DEVELOPMENT
CONSULTANTS, INC.

SUBJECT: 25-040 Loaf Land Subdivision - Comment Response

“LOAF LAND SUBDIVISION” AT MOUNTAIN ROAD, COPLIN PLANTATION, MAINE

C3.1

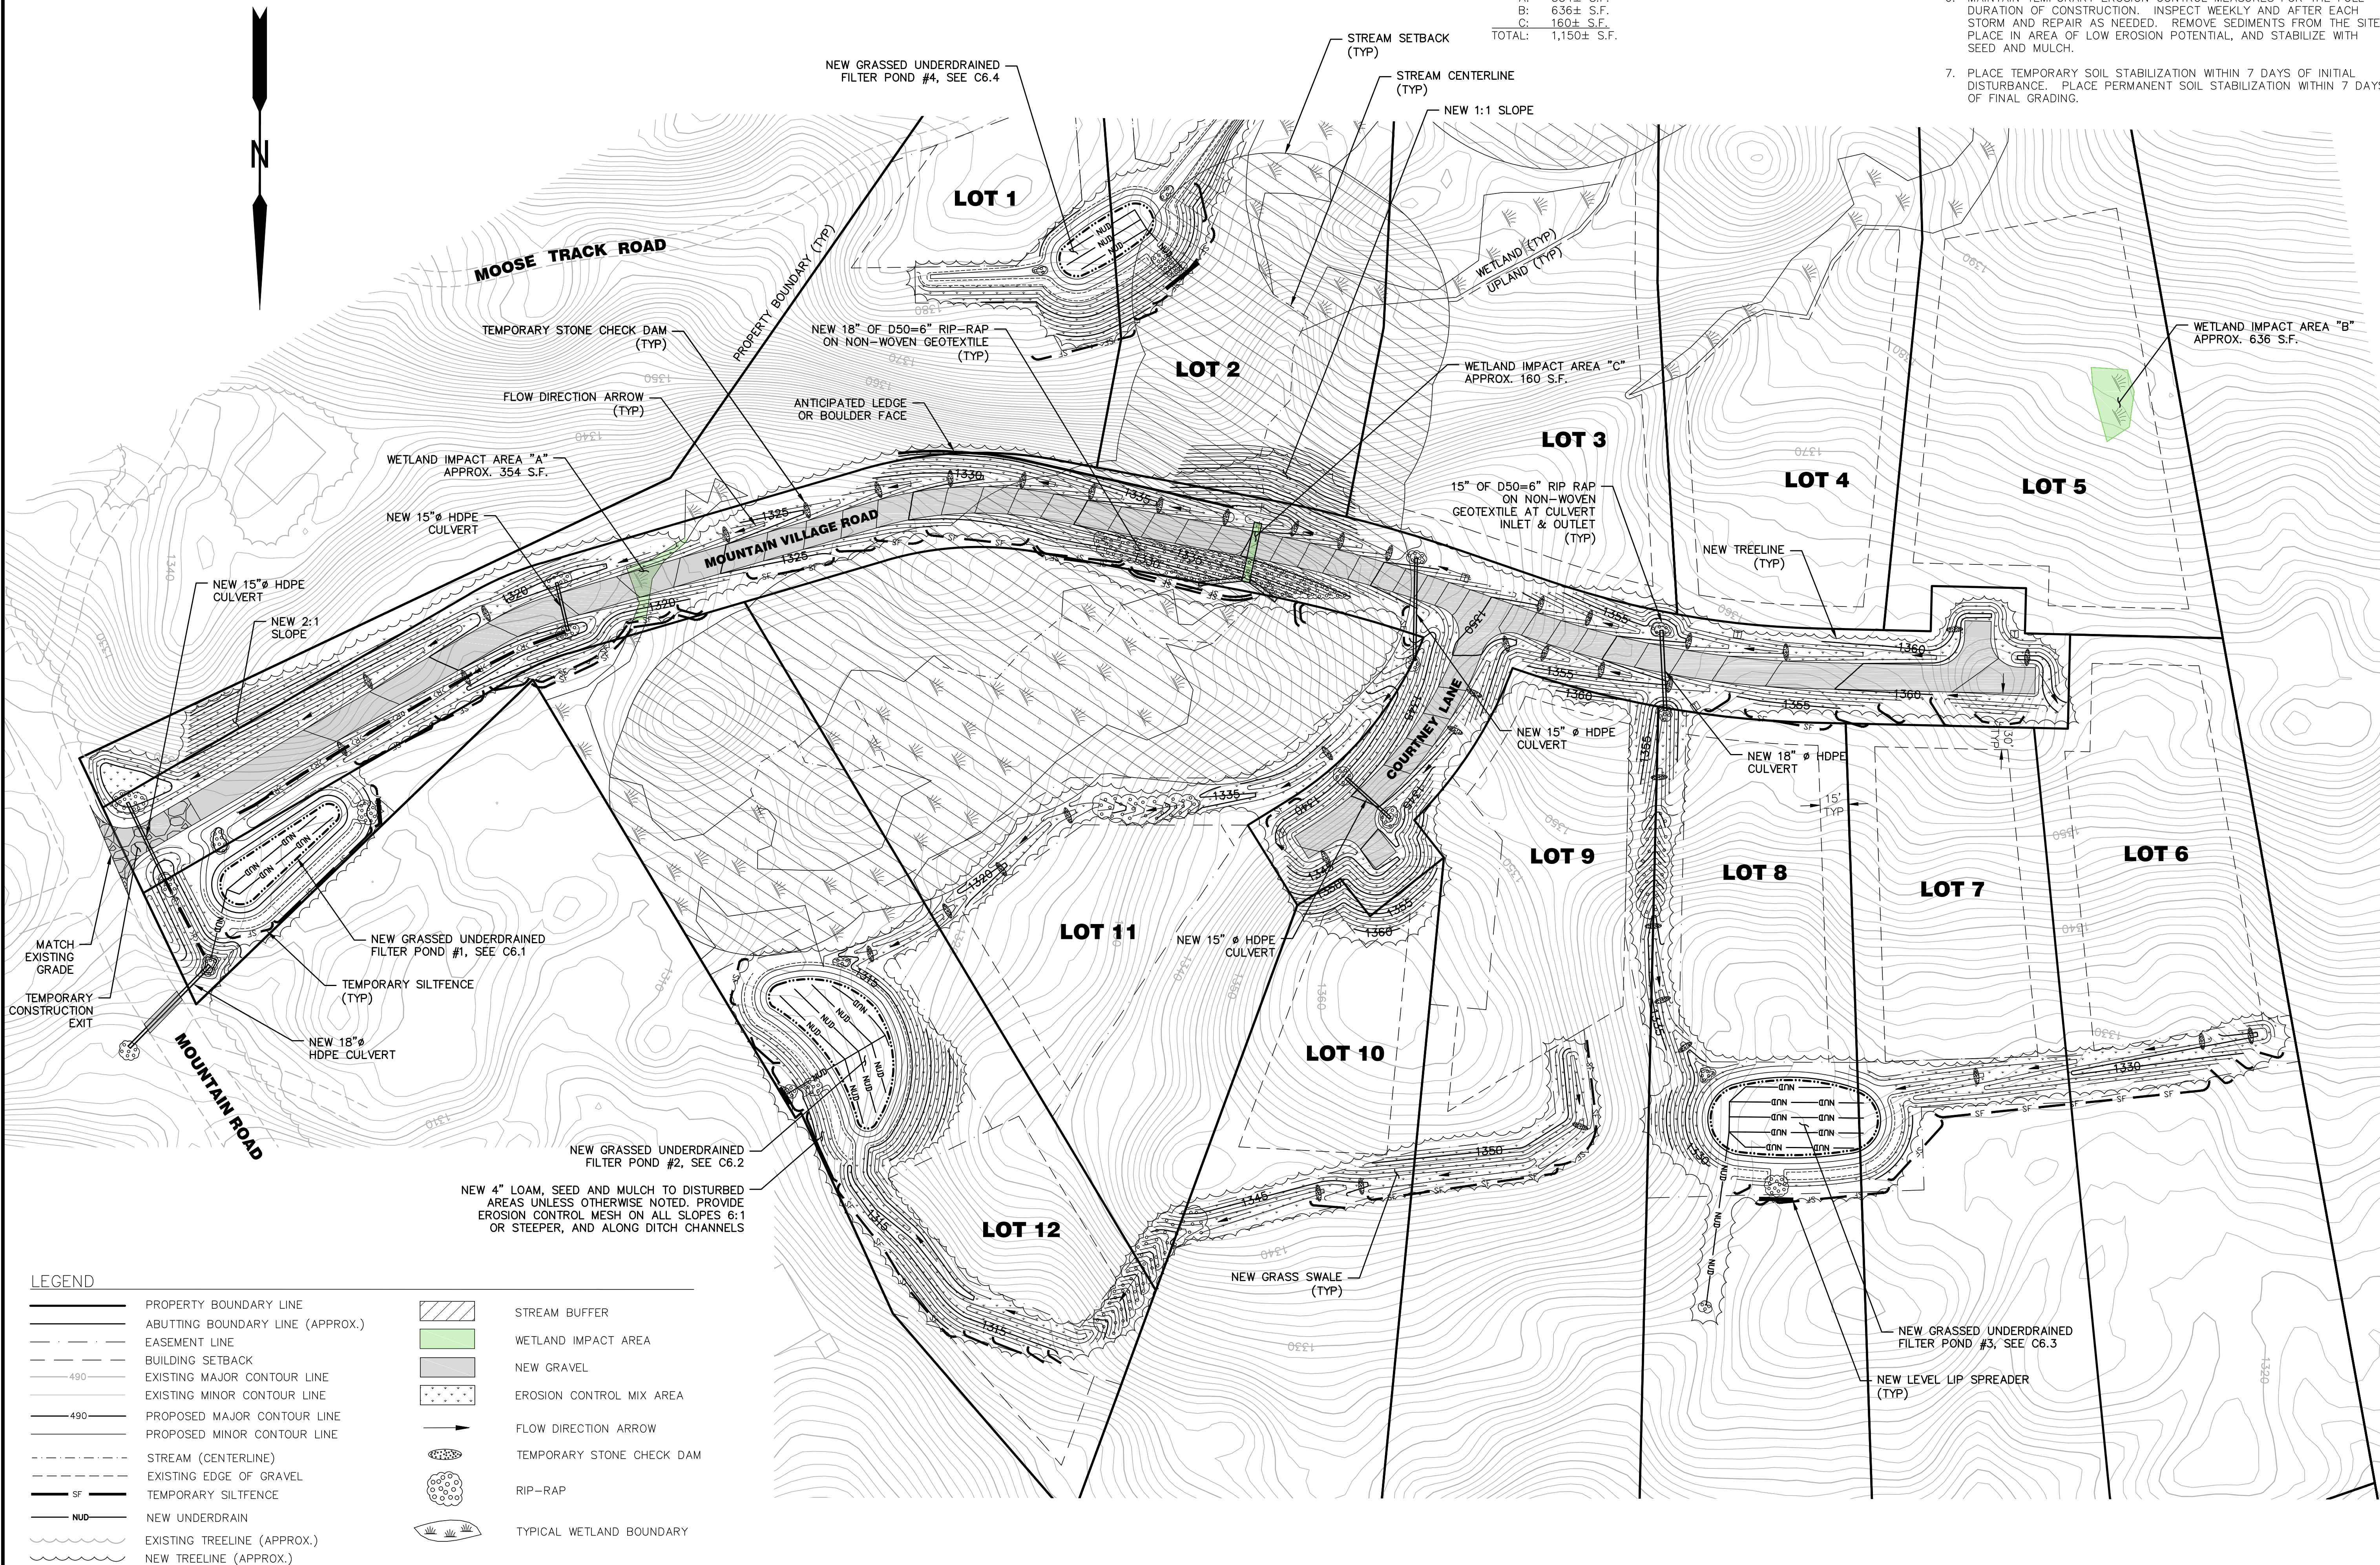
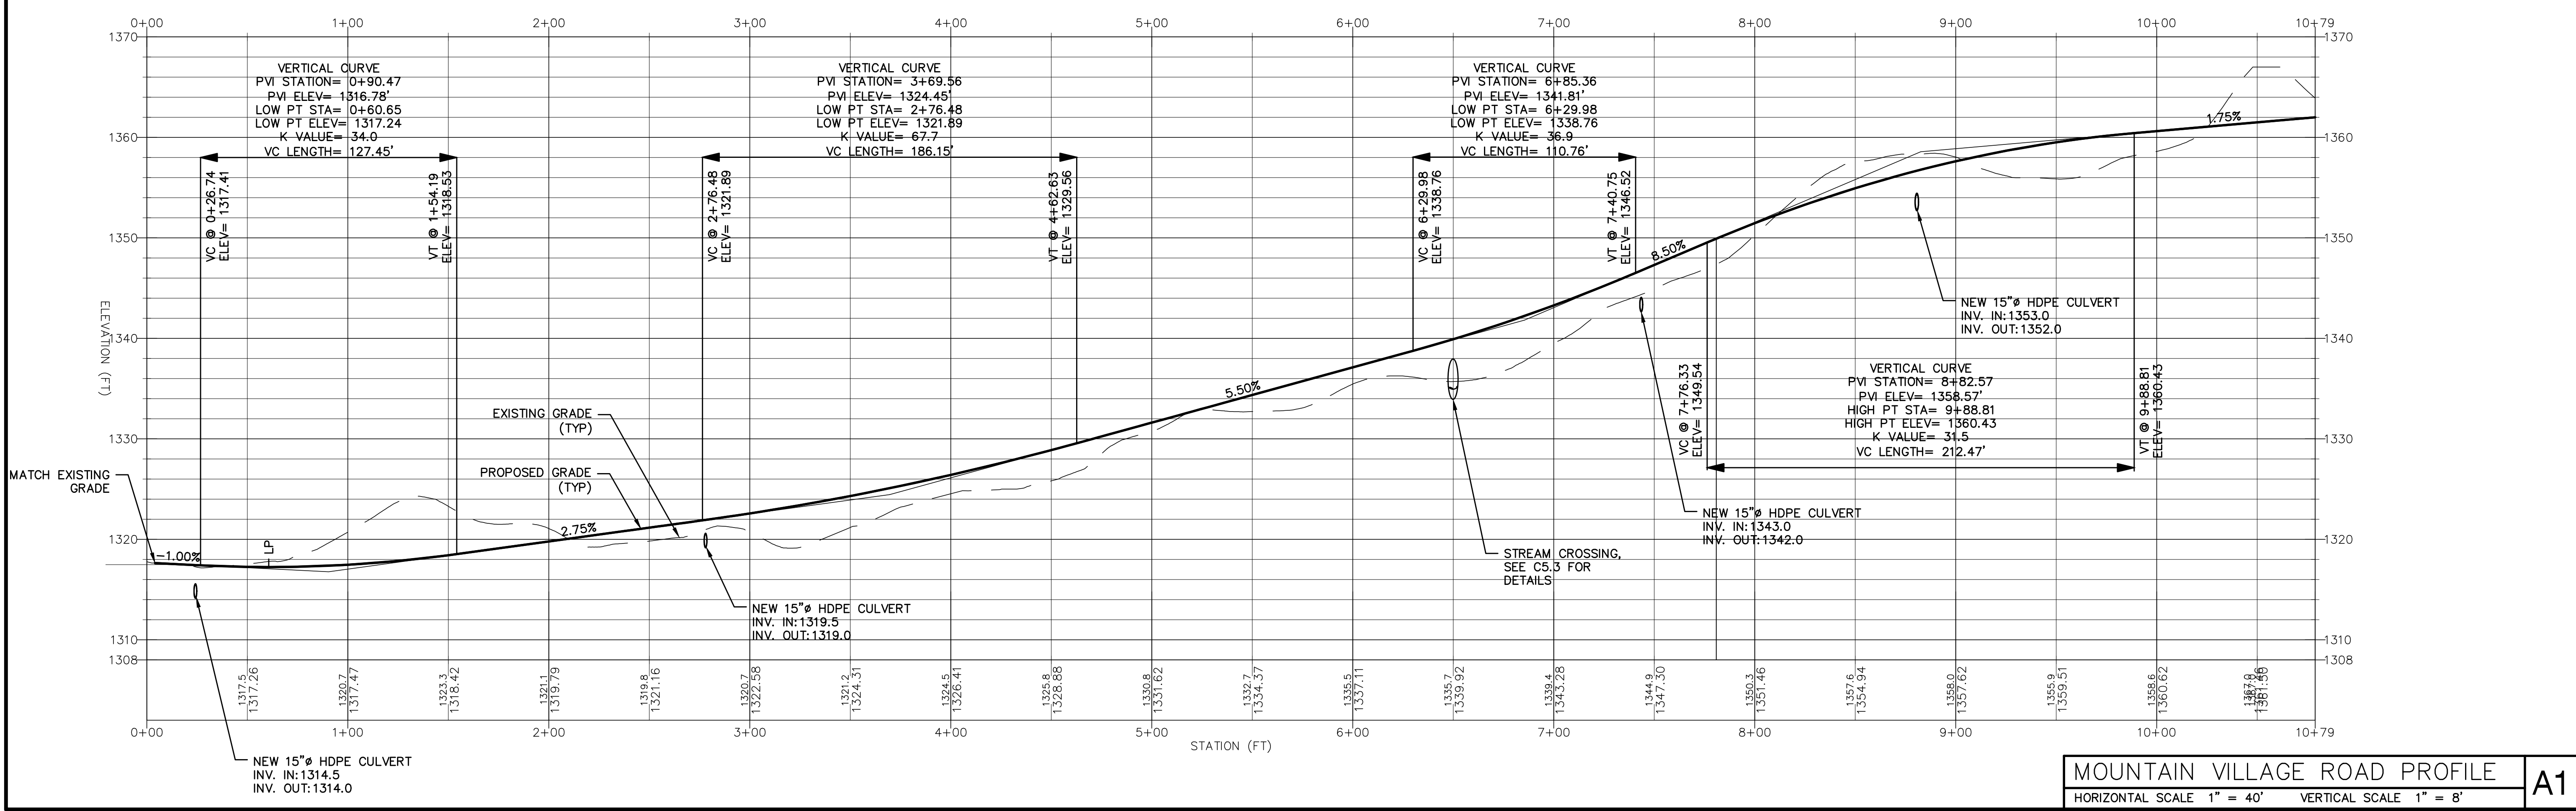
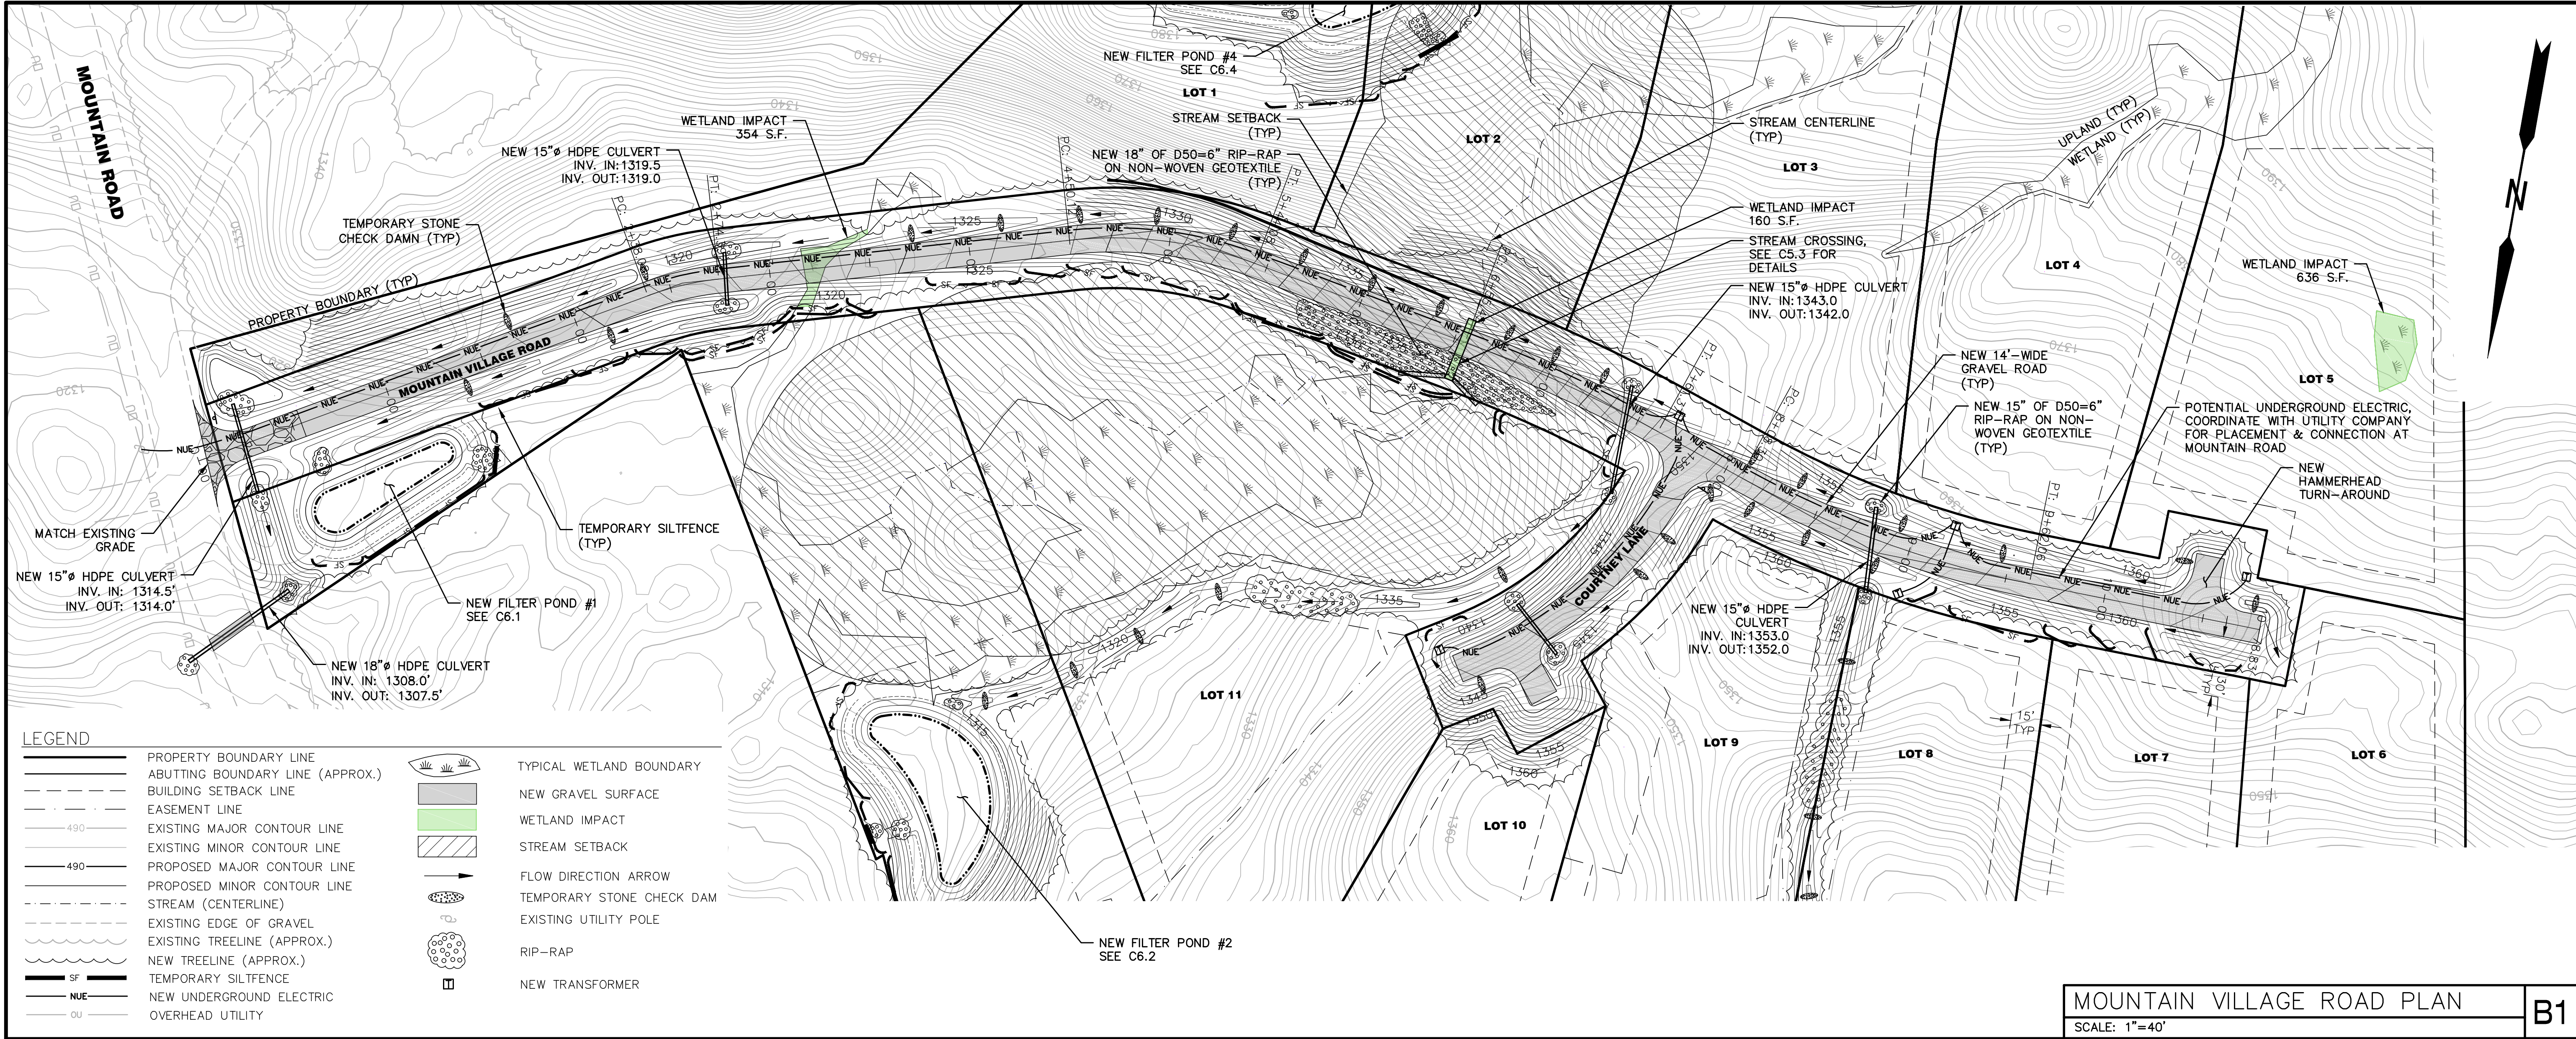
- *On Plan C3.1 (Grading & Erosion Control Plan), wherever side slopes exceed 3H:1V, show the planned slope stabilizing measures and their extents (see Sebago Technics review comment IV.11 on Sheet C5.3).*
 - *Sebago Response: The stream profile appears to indicate the need for a 7 foot-tall wing wall on the outlet side. The plans should better depict the design intent of this wingwall and how wetland impacts will be avoided during its construction. Silt fence is also shown through the wetland in this area with no stated wetland impact in this area. Additionally, the design plans include lengths of side slopes that are at 2H:1V or steeper. It should be shown on the grading plan which slope stabilizing measures are to be used and their extents where the side slope exceeds 3H:1V.*

The design plans have been updated accordingly to reflect those areas.
